# Rezoning Transportation Analysis

Petition Number: #2022-105

Date	Description
11-28-22	First Review (PM)
12-22-22	Second Review (DR)
2-22-23	Third Review (JP)

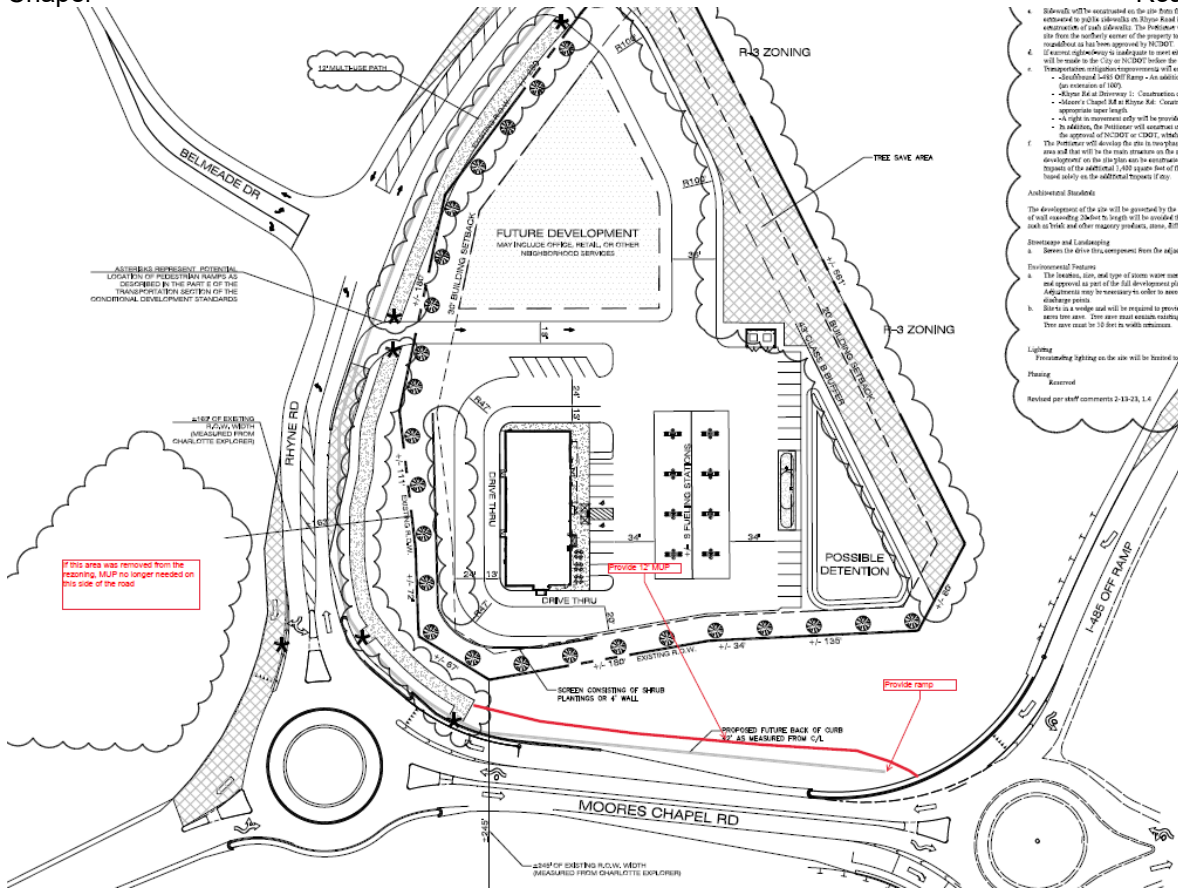
### 2. Revise site plan conditional note in the transportation section letter e. for Southbound I-485 Off Ramp to say, "Extend existing southbound right turn lane to provide 400' of storage and appropriate taper."

**REWORD:**

Extend SBR to provide 400' of storage and appropriate taper.

Existing SBR is 200'.

**Clarifying Comment from 12/22/2022:** Reword improvement at Southbound I-485 Off-Ramp to what is shown in the picture above.
